May 2008

RE: **Second Notice of Recall 2007-01 (NHTSA 07V-036) Brass Connector Fitting (210C Models)**

Figure 1: Photographic image illustrating defective fitting installation.

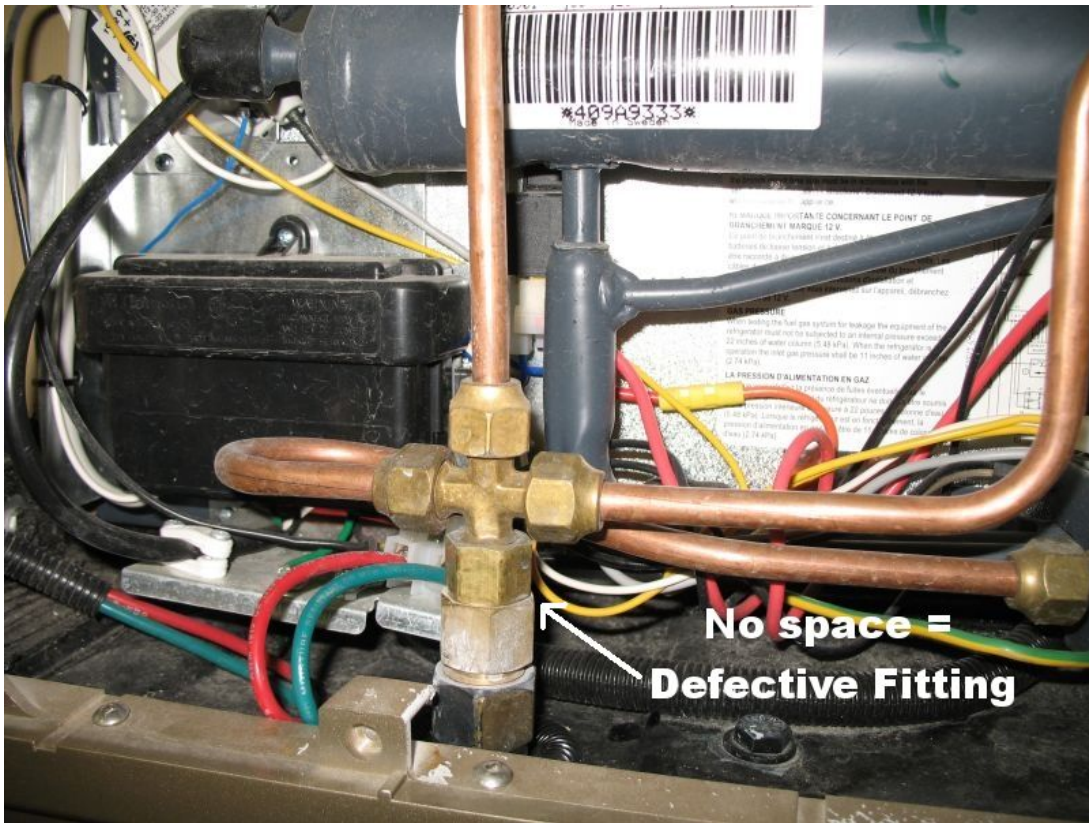
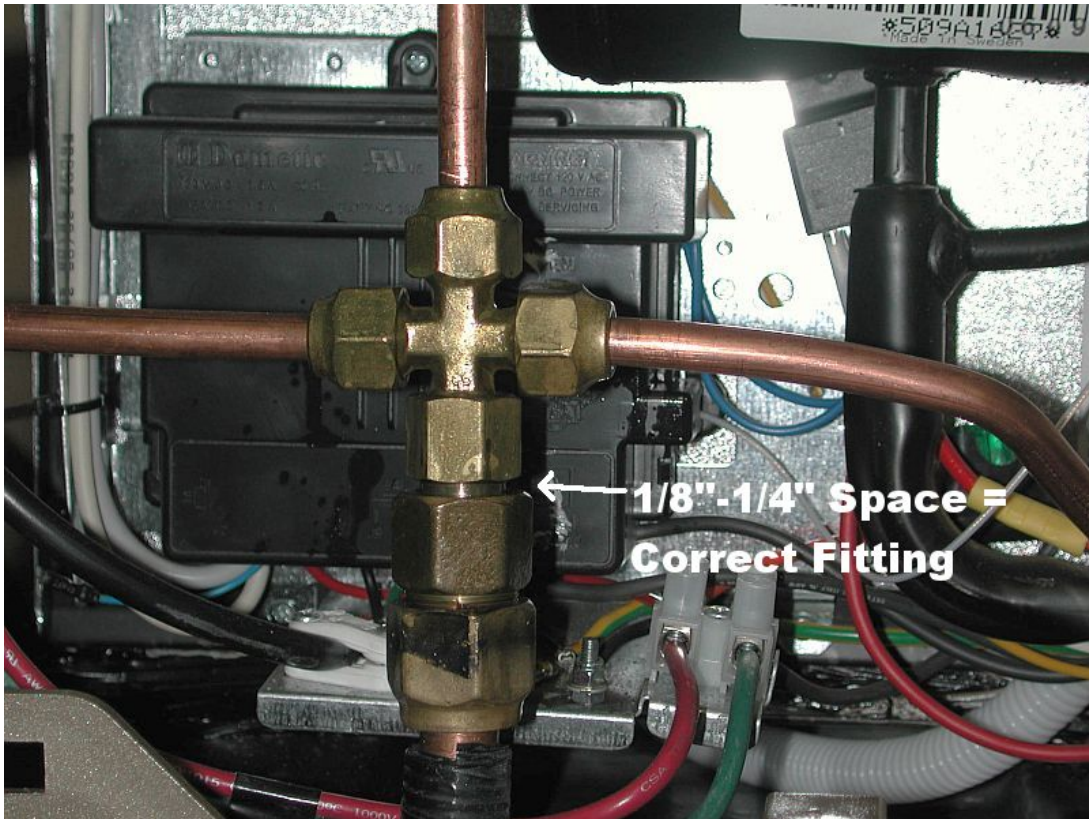
The recall pertains to a brass connector fitting used to connect the copper piping from the motorhome propane storage container to the brass fitting assembly behind the refrigerator. It is a possibility; the connection will leak with vehicle usage, vibration etc., resulting in a possible fire hazard.

Corrective action requires the brass connector fitting to be inspected and replaced if required. This brass connector fitting can be easily viewed from behind the refrigerator exterior access door. See attached photographic images for determining if your vehicle is equipped with a defective brass connector fitting.

You are requested to carry out the inspection. If you have the correct fitting, please complete and return the recall form. If your vehicle is equipped with the defective brass fitting, **do not use the propane system in your Roadtrek**. Contact your Roadtrek dealer for immediate service to replace the fitting.
